1). *Supplementary information on the predicted noise level and noise impacts, both airborne and underwater, on sensitive receivers arising from the use of percussive piling for the construction of wind farm structures of 5 to 7m in diameter.*

(2) Supplementary information on a more detailed construction programme for the detailed design and construction phases.

(3) Further explanation of the cumulative impacts of the Project and other projects including (a) projects near Lamma Island in foreseeable future; and (b) the Black Point Gas Supply Project and the Hong Kong-Zhuhai-Macao Bridge Project.

(4) Further explanation of the following ecological aspects in response to the comments raised by some members of the public:

Figure 2- Migration route of a foraging green turtle in Gangkou (China) in the summer of 2007 and passed through Hong Kong waters during its migration to the Wanshan Archipelago (Map provided by AFCD).

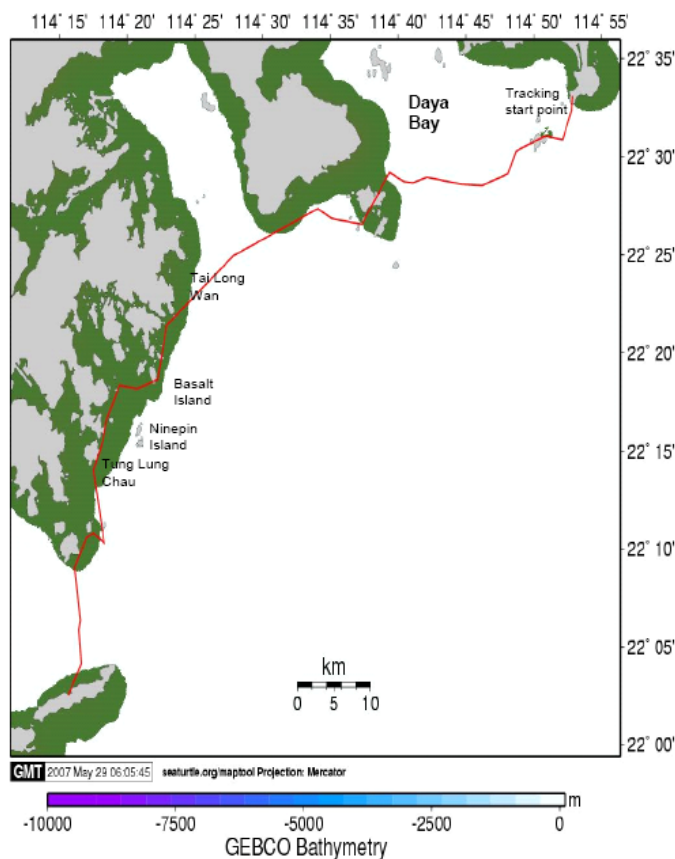
- **potential impacts on Green Turtle with respect to the migratory pathways, effects of potential electromagnetic field generated by the Project and underwater sound generated during construction works**

The finding of the assessment is that the proposed wind farm is likely to have negligible impacts on the post-nesting migratory pathway of sea turtles. Sea turtles show plasticity in the post-nesting migratory routes, with observations of sharp deviations in migration to avoid underwater obstacles ⁽⁴⁾. While there is currently no evidence to suggest that the wind farm will directly obstruct the turtle migratory route, the plasticity in migration indicates that even if the routes were obstructed marine turtles could make deviations to avoid the wind farm structures. In addition, it is noted that there is a tendency of marine turtles to use coastal areas during migration, which has been documented in studies by AFCD and international literature (see *Figure 2* below).
